WORK PLAN ADDENDUM I
RCRA FACILITY INVESTIGATION
VAN WATERS & ROGERS, INC.
3950 NW YEON AVENUE
PORTLAND, OREGON

HLA Job No. 9695,105.02

March 6, 1989

Proposed Monitoring Well Locations
Work Plan Addendum I
Van Waters & Rogers, Inc.
Portland, Oregon

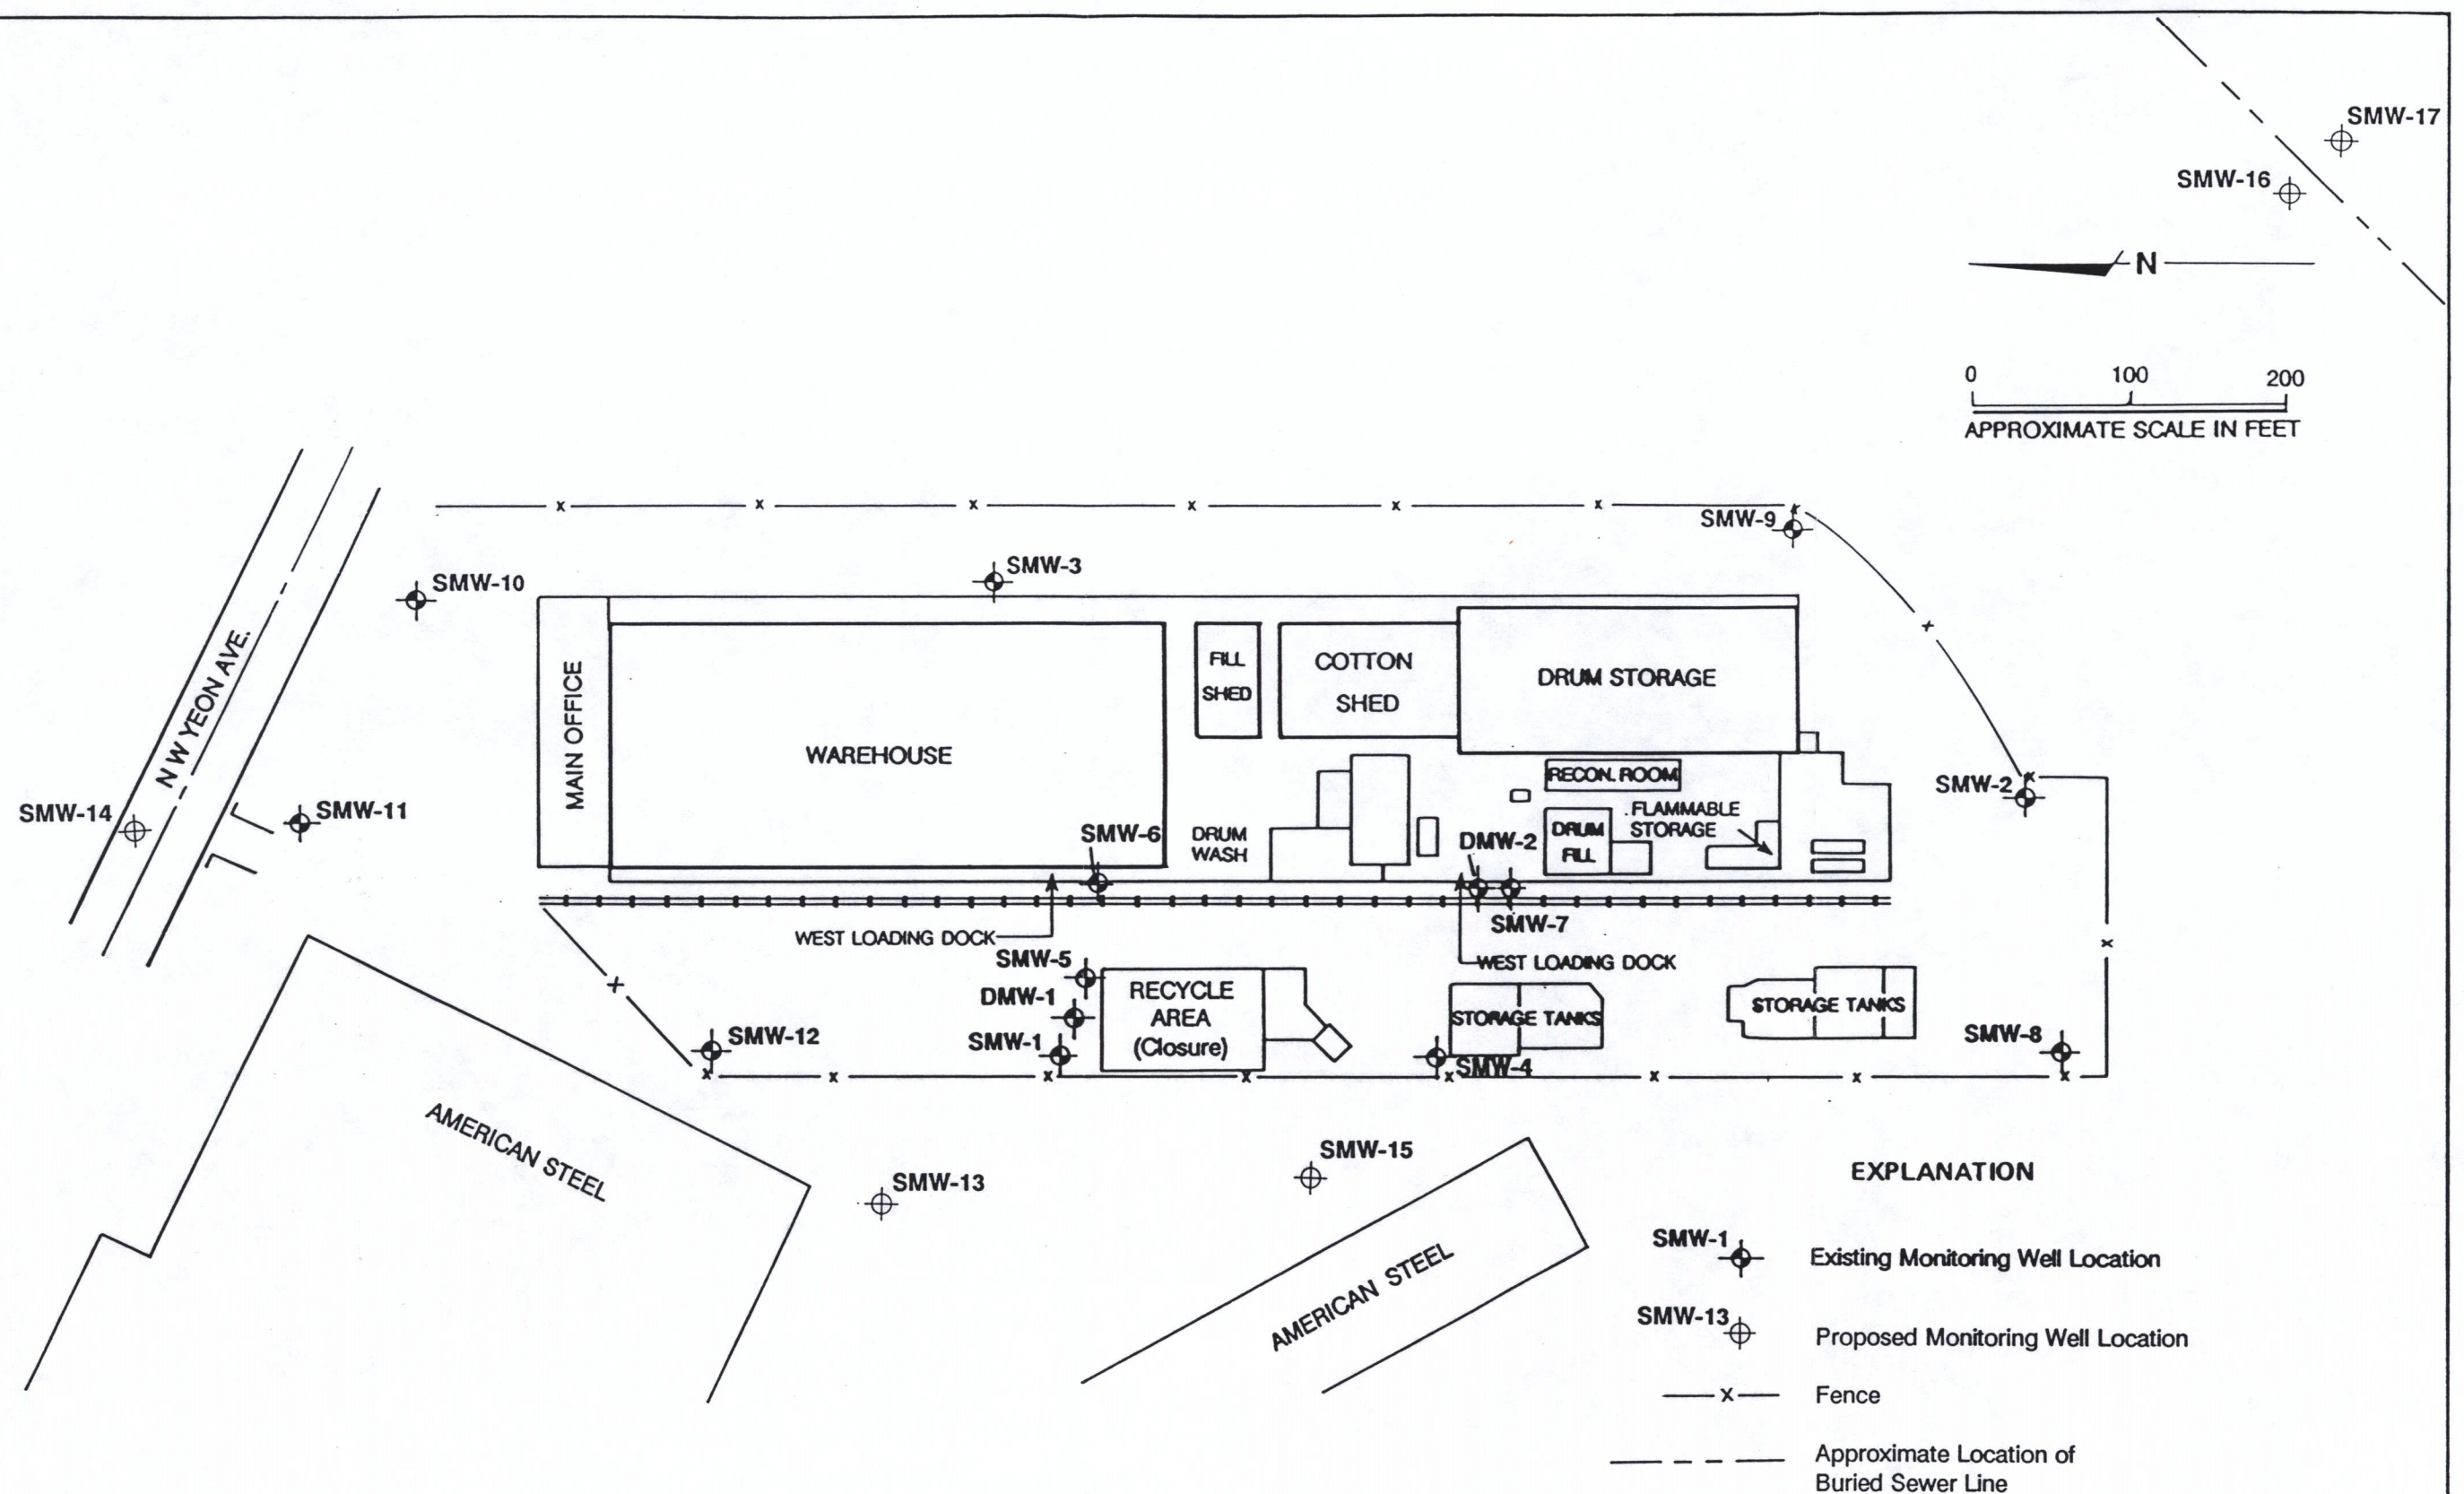
To further describe the horizontal and vertical extent of chemicals in ground water and to assess the possibility that chemicals from off-site sources are migrating onto the VW&R site, five additional shallow aquifer ground-water monitoring wells will be installed off site (Plate 3).

Proposed off-site shallow Monitoring Wells SMW-13, -14 and -15 are to be installed downgradient of the VW&R facility to assess the potential for off-site migration of chemicals.

Proposed Wells SMW-16 and SMW-17 have been sited upgradient of the VW&R facility to evaluate the possibility of chemicals in the ground water migrating onto the facility from an off-site source(s). These wells will be installed on either side of an abandoned sewer line to assess whether the sewer line and surrounding backfill act as a conduit for chemicals. Ground penetrating radar (GPR) will be used to locate the sewer line and backfill.

**Below-Grade Monitoring Well
Completion Diagram**
Work Plan Addendum I
Van Waters & Rogers, Inc.
Portland, Oregon

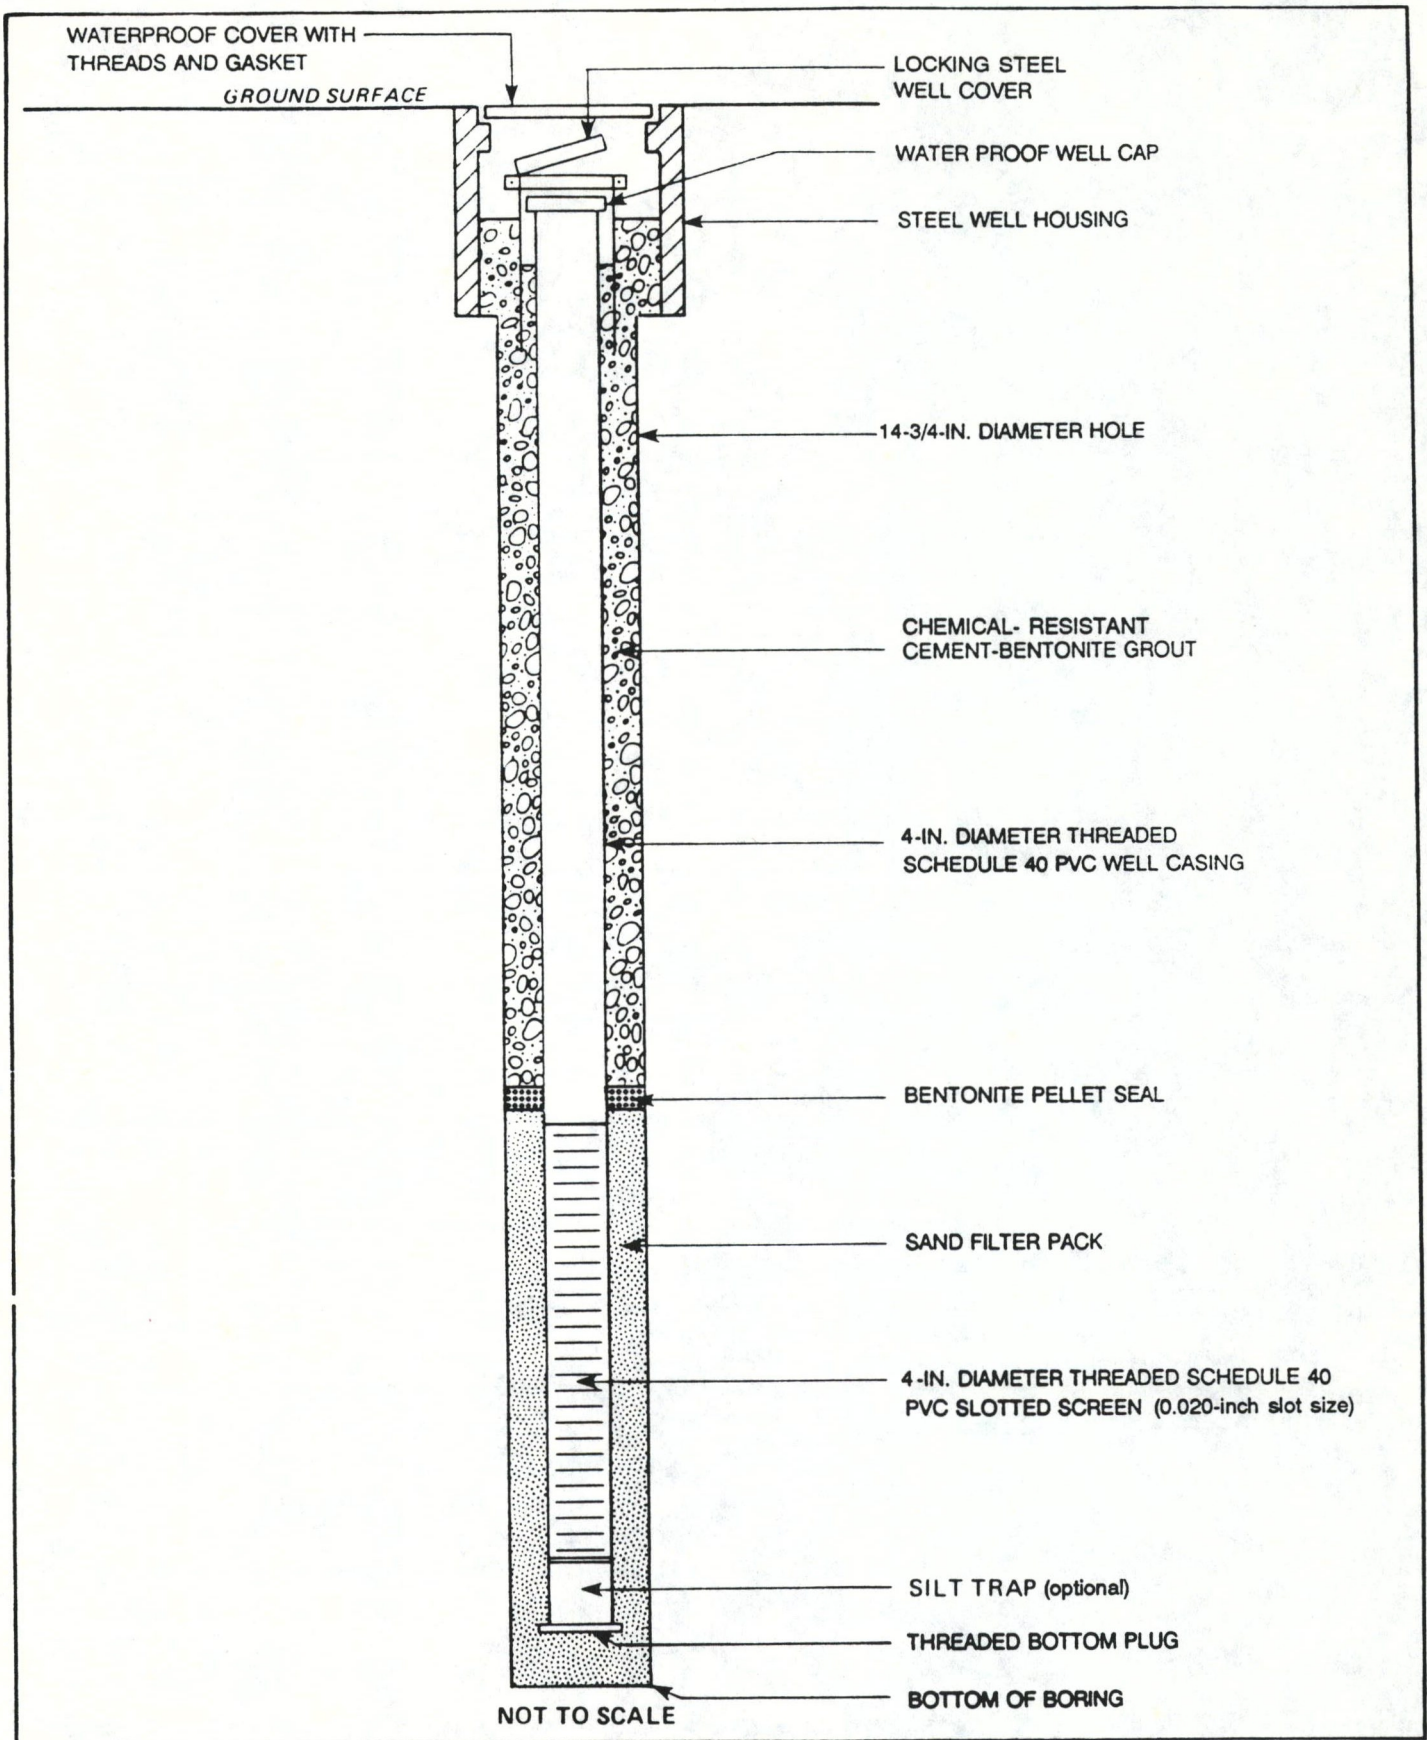
The wells will be drilled using hollow-stem auger methods and will be single cased using procedures described in Section 5.4 of the DCQAP. A typical monitoring well completion diagram is shown on Plate 4. The relevant property owners will be approached for permission to install these monitoring wells on their property. A sample letter, "Off-Site Monitoring Well Installation Permission," is provided in Table 6 of the Work Plan.

Proposed Soil Boring Locations
Work Plan Addendum I
Van Waters & Rogers, Inc.
Portland, Oregon

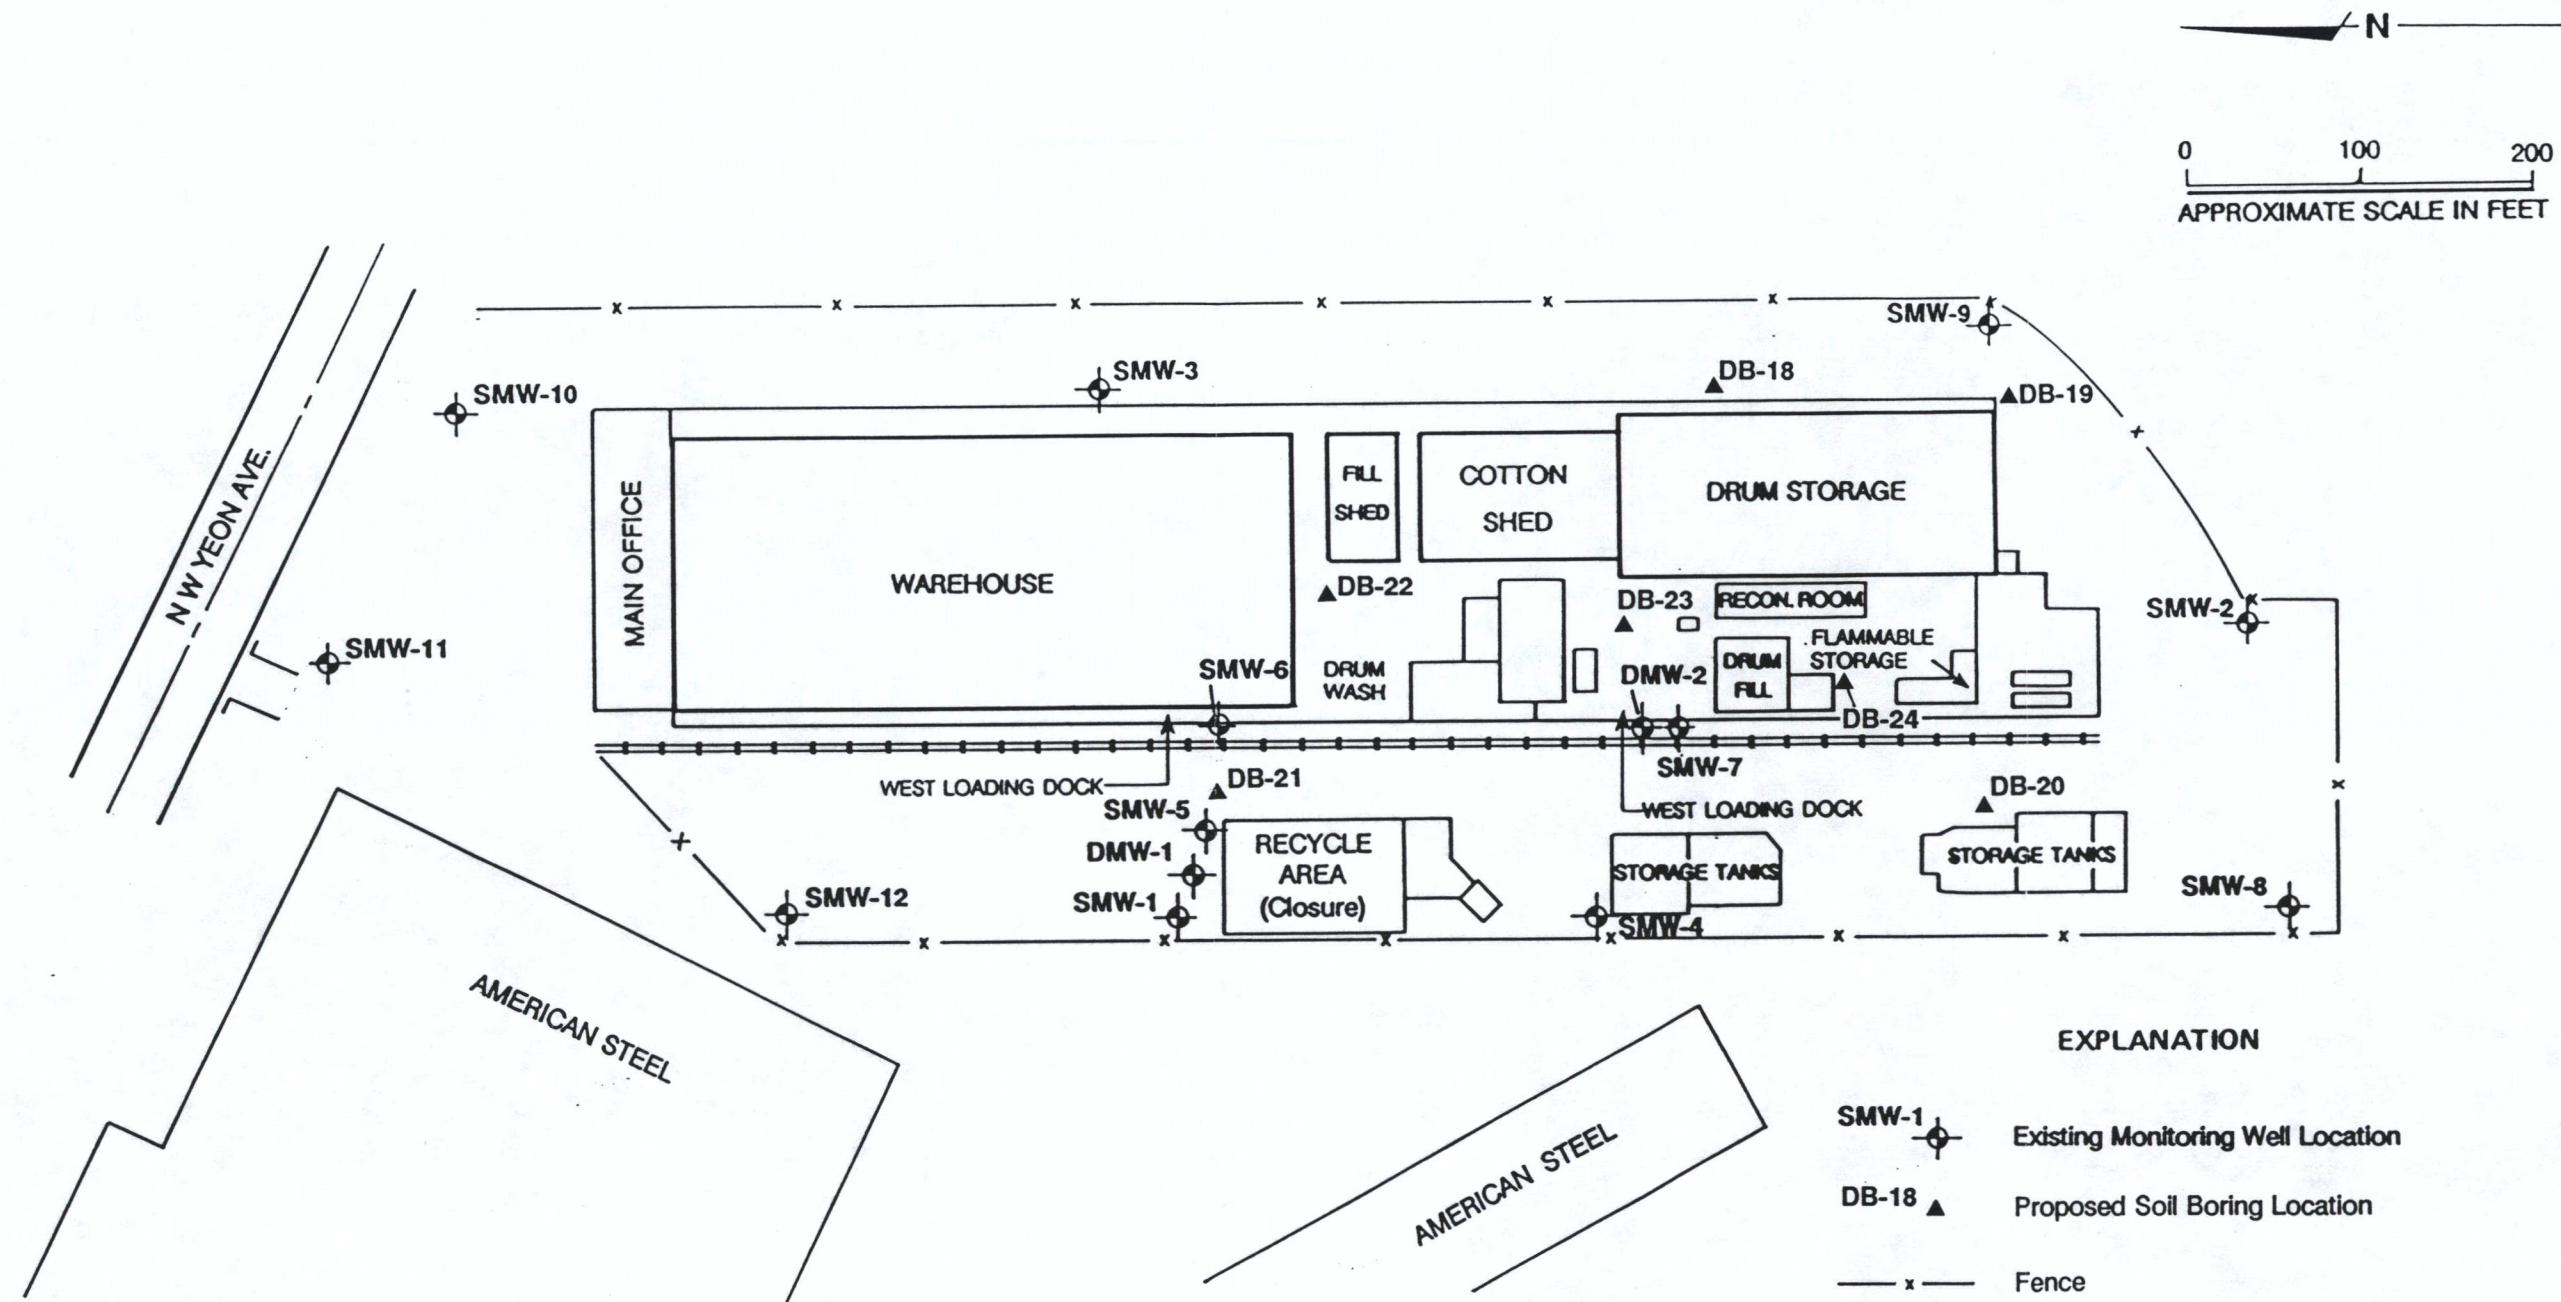
Seven soil borings (DB-18 through DB-24) will be drilled on the VW&R facility at the locations proposed on Plate 5. All borings will be drilled to the ground-water surface in the shallow aquifer zone (approximately 6 to 14 feet below ground surface) using procedures described in Sections 5.0 and 6.0 of the DCQAP.

Proposed Borings DB-18 through -21 will be drilled in areas where soil gas readings were elevated (*HLA, 1989d*). Borings DB-22, -23 and -24 will be drilled on the dock to characterize and assess the vadose zone and ground water quality in this portion of the facility. GPR will be used to locate any underground obstructions prior to drilling the borings on the dock.
